Service Manual

SUZUKI Automobile Genuine
AM/FM 6-Disc CD Changer Deck

Model PS-2533B-C,D
(Genuine No.39101-55GF1-000)

Difference from original models is beep sound function.

(Reffer to page7 of original model's manual.)

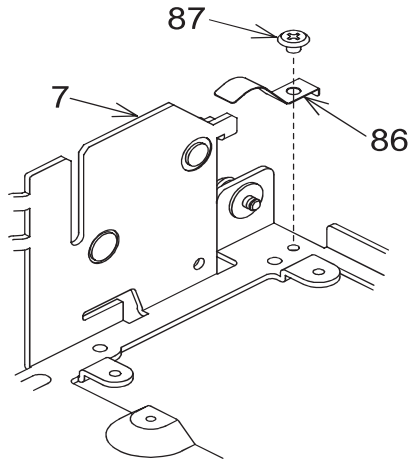
CD Changer mechanism section : Main module
(Reffer to page7,8,9 of original model's manual.)

Original models also use below updated parts.

NO.	PART NO.	DESCRIPTION	Q'TY
7	966-0597-24	CHASSIS ASSY	1
85	347-6974-21	FPC COVER	1

Original models also use below added parts.

NO.	PART NO.	DESCRIPTION	Q'TY
86	620-1604-20	DR-PLATE-SPRING	1
87	716-1850-01	SCREW(M2 x 2)	1
